## INDEX TECHNICAL SERVICE BULLETIN

PRODUCT:  
**ADx® (59)**

SUBJECT:  
**CE Mark Certified ADx® Instruments and Modification**

TSB#: **59-017**

**Figure 1**

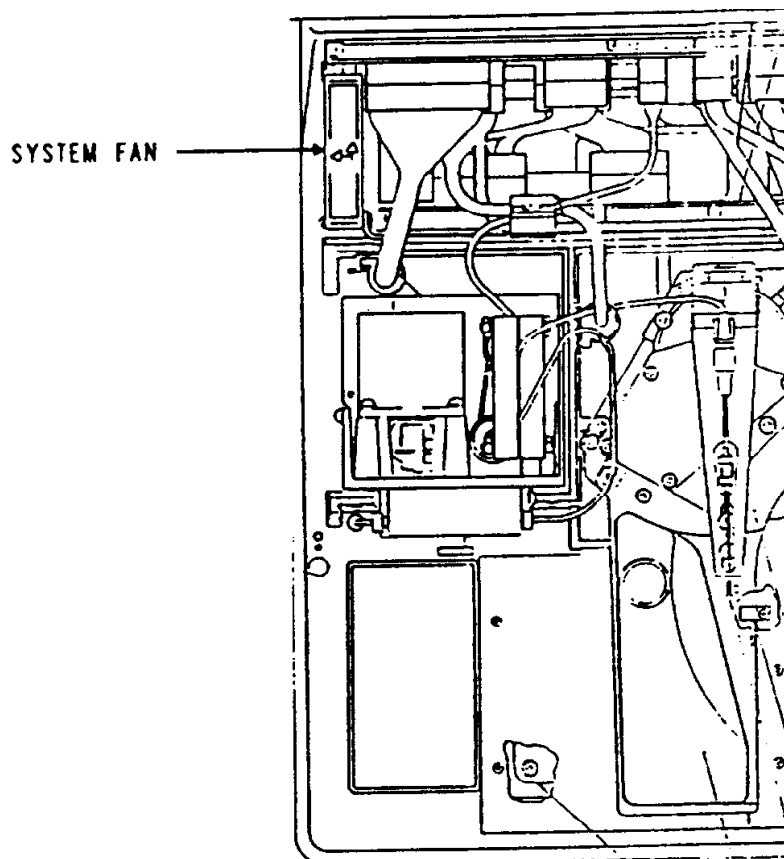
1. Turn the ADx analyzer OFF and unplug the instrument from the wall outlet.
2. Open the keypad access door and disconnect the two cables from the keypad.
3. Slide back the clamps that hold down the ADx enclosure being careful to remove the safety screw from the clamp on the inside right front.
4. Remove the ADx enclosure.
5. Locate the system fan on the left side of the instrument PCB enclosure. See Figure 1.

**Figure 2**

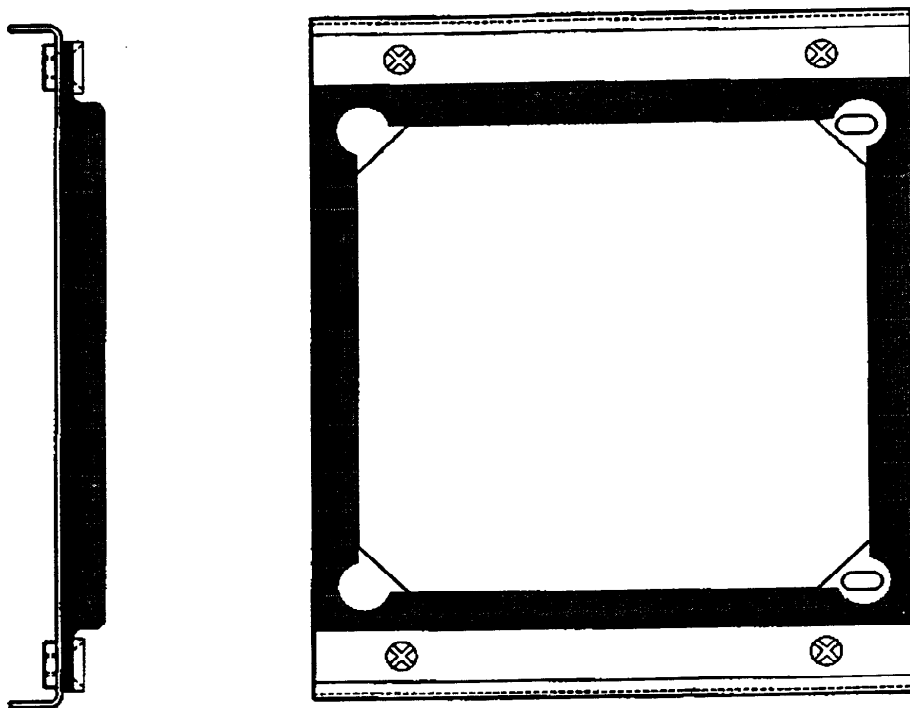
6. Remove the two mounting screws that hold the fan to the fan bracket.
7. Place the fan gasket over the fan being sure that the rubber portion of the gasket faces away from the fan.

**NOTE: The gasket will only fit one way. Hold the gasket as shown in Figure 2 with the two mounting holes on the right side.**

Figure "A"

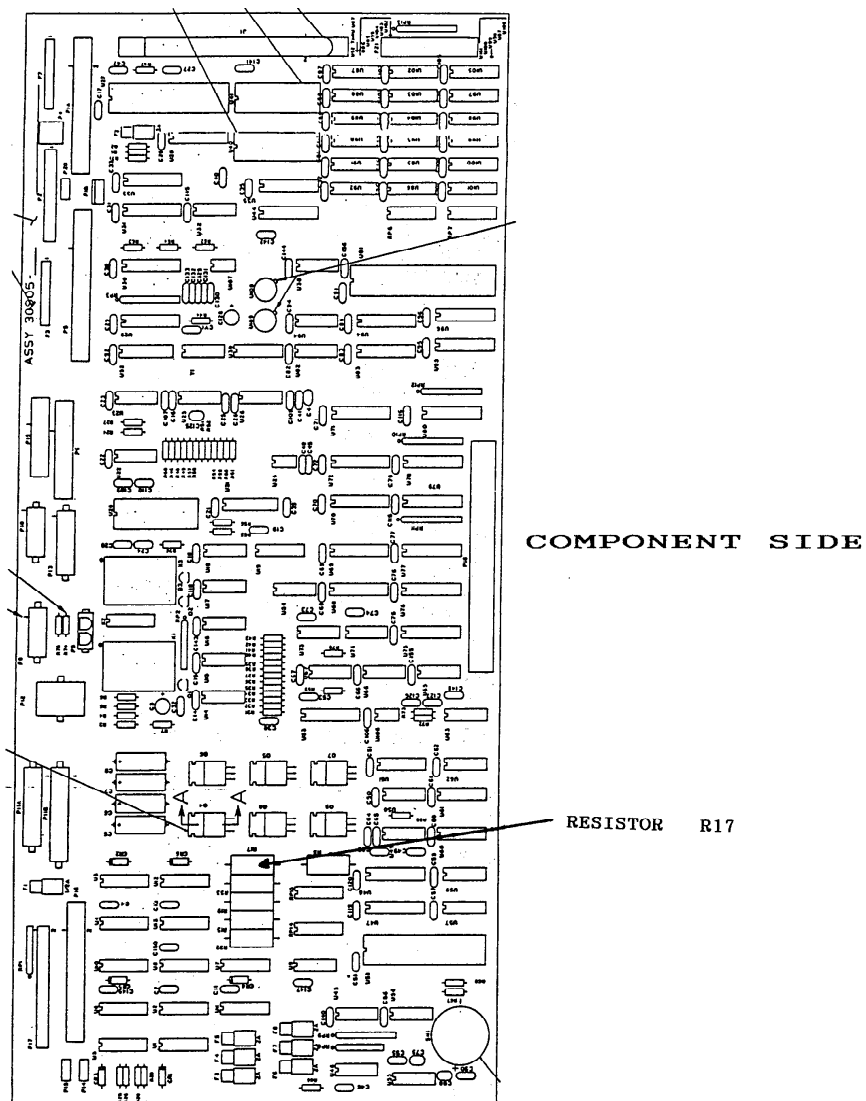
4. Remove the System/Logic PCB from the instrument. Use anti-static measures when working with this PCB.
5. Locate resistor R-17 using Figure "A" of this TSB.

6. Using side cutters remove the resistor leaving the leads in the board.
7. Solder the replacement resistor to the leads you left protruding from the board.

Figure "A"

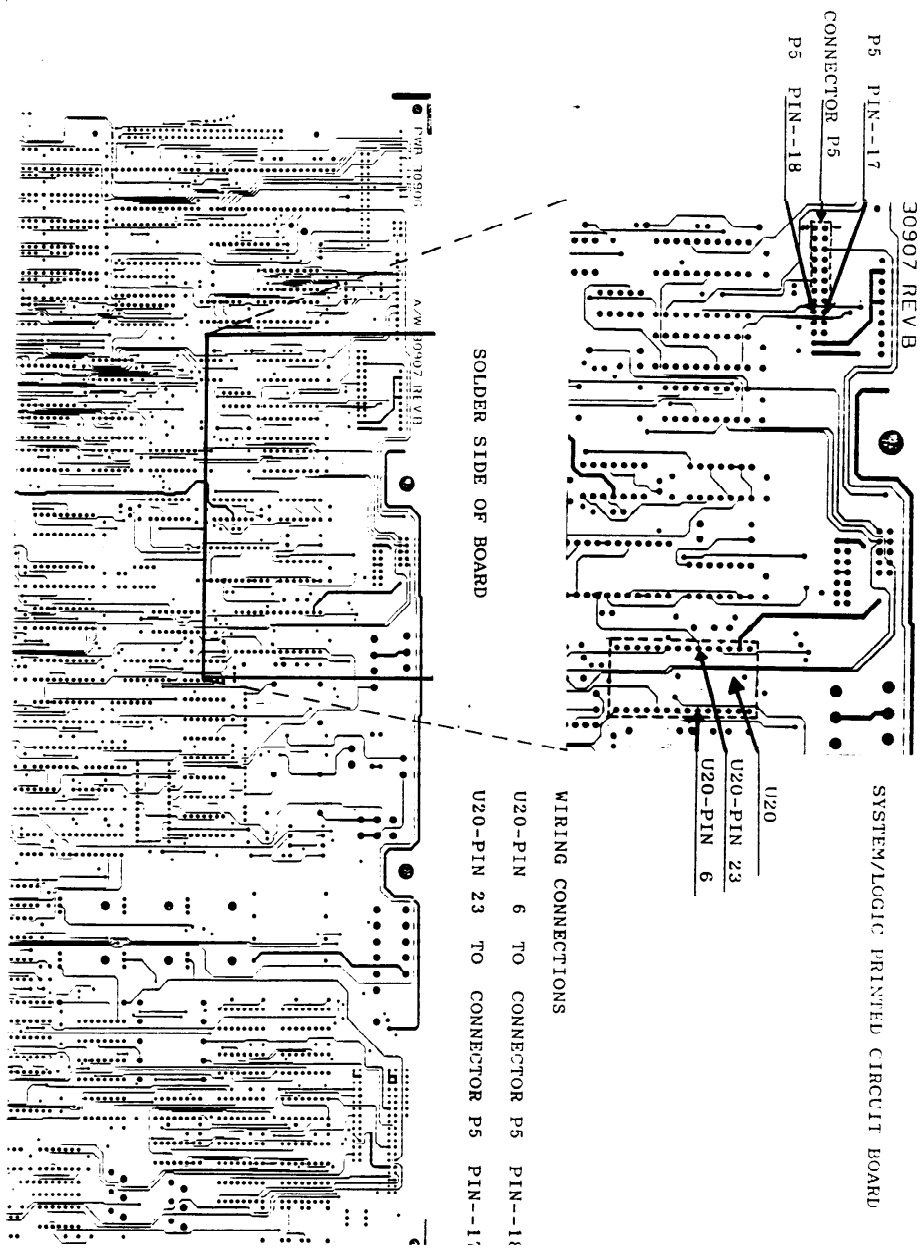
The System/Logic PCBS (-102, -103, and -104) must be modified before the internal thermometer is installed. Refer to Figure "A" for the location where the capacitor must be added to the System/Logic PCB. this capacitor reduces noise being transmitted to the input of the multiplexer. If this capacitor is not in place, Temp Cal and Temp Verify may fail.

When performing this modification verify the correct part number of the optics assembly and System/Logic board which will indicate the parts needed to modify. Optics assembly part number is 30957-103 (or higher). This assembly has the connector and circuit for the internal thermometer assembly. System/Logic board part number is 30905-102 (or higher). This assembly is modified for the internal probe assembly. If the part number is correct but the wires on the back of the board are broken use drawing Figure "A" to repair the broken wires.

Figure "B"

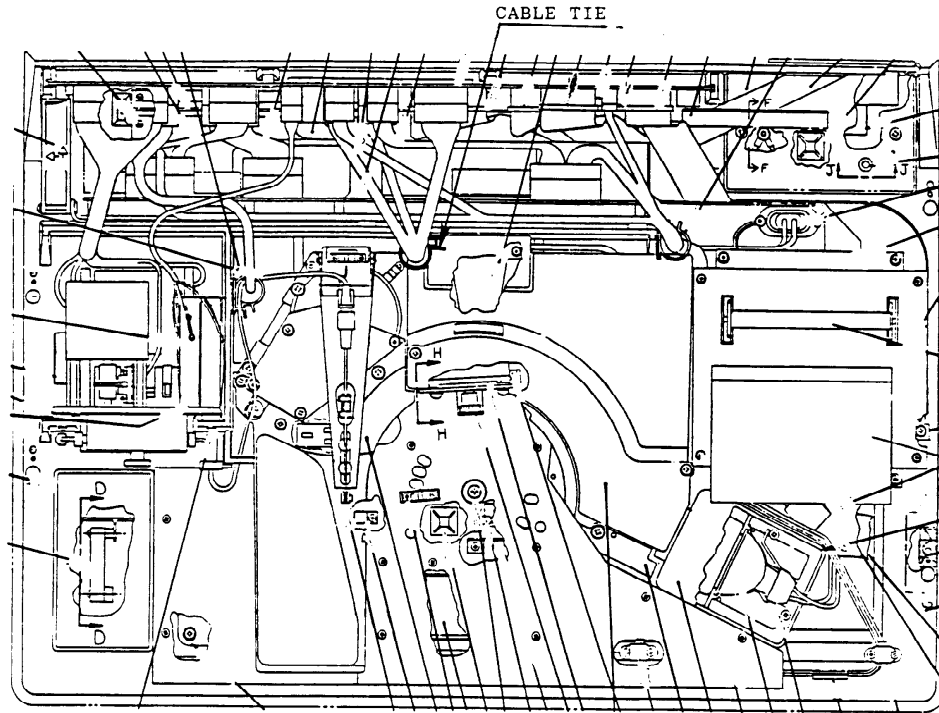
5. Install the replacement optics assembly and connect the internal probe intermediate cable assembly to the connector on the Optics PCB.
6. Reassemble the optics and cover assembly, remove the cable clamp attached to the back wall if required (see Figure "B").

Figure "C"

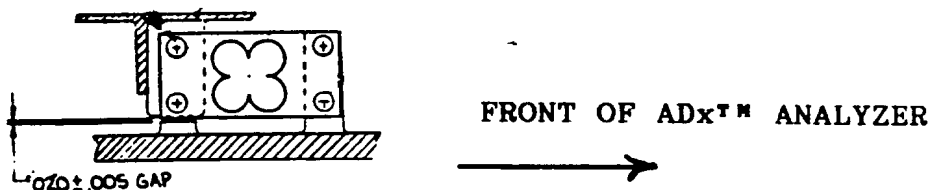
10. Connect all cables to the System/Logic PCB and install the F.S.M.M.. Remove the old style buffer platform, use Figure "C" to set the transducer gap adjustment. Install the new buffer platform. If the boom needs the boom weight added do it at this time. Figure "D" indicated the location for the boom weight.

Figure 1

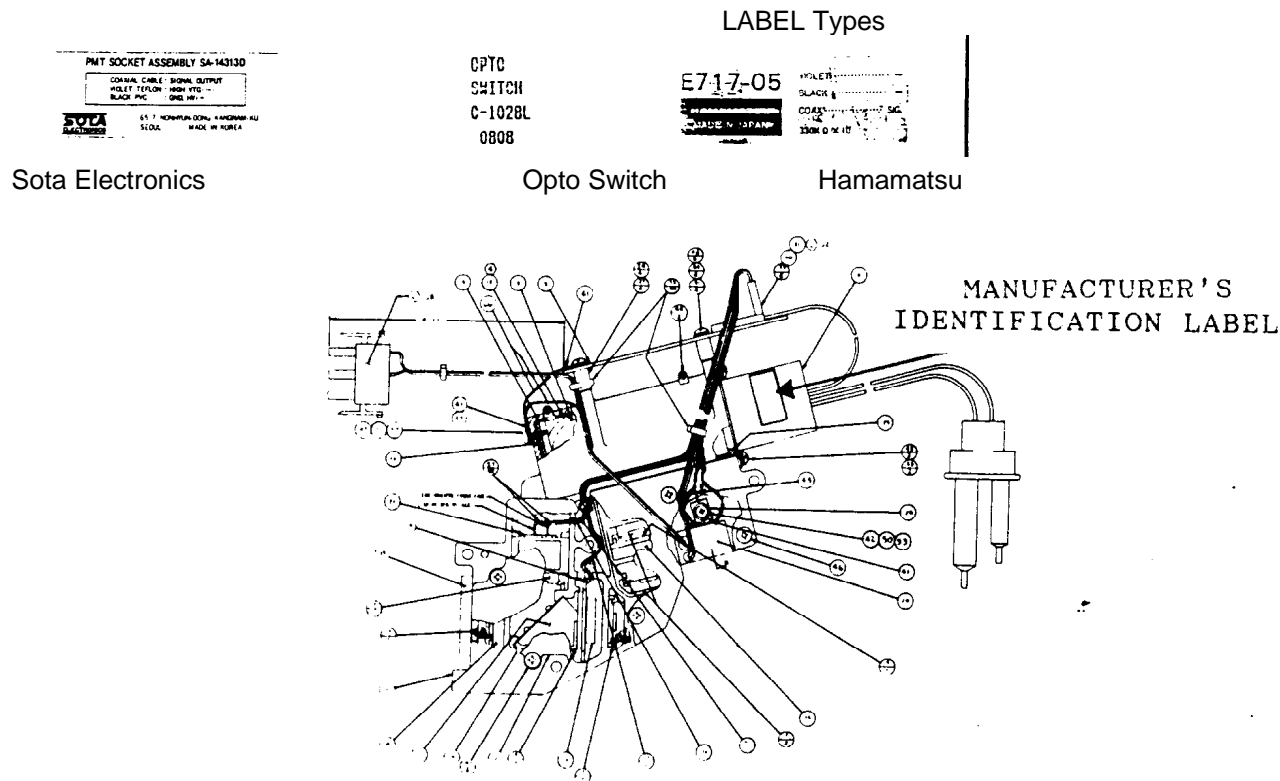
SYSTEM	1.0
CONFIGURE	1.3
DIAGNOSTICS/PARAMETERS	3.1
PROCEDURES/TABULATION	4.4
2. Turn the ADx™ analyzer off and unplug the power cord.
3. Open the main door and remove the splash guard to gain access to the Optics Assembly.
4. Inspect the PMT Socket for a manufacturer's identification label (See Figure 1). Hamamatsu and Sota Sockets will have a Silver Label with light blue print. It is IMPERATIVE the label be read to determine its type. Opto Switch Sockets DO NOT have a silver label. they are stamped with WHITE INK. If sockets are found which do not have any labels at all, they are to be treated as NON-CONFORMING sockets.

5. Replace all PMT Sockets which do not have the Hamamatsu Label.
6. If the socket is correct, re-assemble the ADx™ instrument. Use the following procedure after power up of the instrument and "Warm-up" is complete.
  - a. If the Optics WAS NOT removed,  
**GO TO STEP 5 (IF OK, SKIP 6 AND 7) CONTINUE ON WITH STEP 8 OF THE AFTER RE-ASSEMBLY PROCEDURE.**
  - b. If the optics WAS removed to verify the label,  
**GO TO STEP 1 OF THE AFTER RE-ASSEMBLY PROCEDURE AND PROCEED WITH CALS AND CHECKS.**
